ABLE UK LTD.

FINALISING ENVIRONMENTAL ASSESSMENT AT THE
TERRC FACILITY
ADDENDUM TO DNV REPORT 2004-1387

REPORT No. 2005-1024

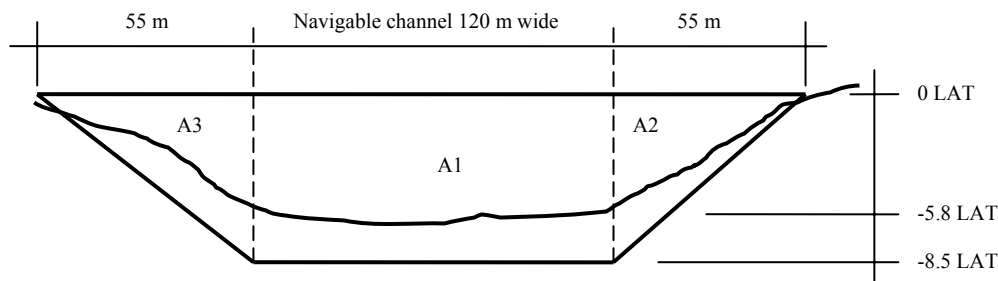
The description of the baseline hydrodynamic condition in Chapter 20 of the EIS apparently takes no account whatsoever of the very large scale cooling water flow abstracted by the power station from the Seaton Channel. This abstraction point is immediately adjacent to the proposed developments. The volume involved is 35.5 m³/s which is significantly in excess of, for example, "relatively high river inflows" of 25 m²/s.

Appendix 8 which describes the DNV modelling assessment, also apparently takes no account whatsoever of the scale of that abstraction when assembling or validating the hydrodynamic model. Since the sediment transport model is also based on that hydrodynamic model and apparent omission, little trust can be placed in its output. Since the output of these models has direct bearing on the likely implications of this proposal for our own operations, we are most concerned about the likely impact.

The proposed modifications to Able UK frontage and deepening of the navigational channel will lead to an increased scour of the shore fronting the power station enhancing rates of geomorphological change. This may result in an increased rate of drawdown of the shore fronting our site.

Shipping movements will present an additional hazard to our operations, especially if such traffic is unwieldy or involves hazardous materials. Such traffic may increase the levels of solids in suspension locally (this again being entrained by our CW system) and potentially increase erosional rates on our frontage.

Appendix 8.2 paragraph 1.1.7 says that "...The Channel is currently subject to maintenance dredging...". We believe that the Channel is not subject to any maintenance dredging at present.

Although the magnitude of the cooling water abstraction was not appreciated at the time of the study, we are confident that the conclusions based on the hydrodynamic and sediment transportation modelling are justified.

As discussed in the DNV Report Chapter 5.3, the computer model was set up with only fluvial and tidal processes to ensure full understanding of the underlying hydrodynamic and sediment transport processes. The other natural and man-made influences such as storms, waves, traffic and dredging were added in the discussion in Chapter 10. This created a comprehensive understanding of the implications of all processes in the estuary.

The findings were supported by other studies carried out by HR Wallingford /3/ and Durham University /2/. These studies describe the observed processes in the estuary and do therefore include the cooling water abstraction.

To put the abstraction into perspective, the net inflow from the 35 m³/s abstraction is studied. At the most narrow point, at the mouth of Seaton Channel towards the Turning Circle, the channel is 230 m wide at low water, with the middle section 120 m wide and 5.8 m deep. At the sides the channel slopes to 0.
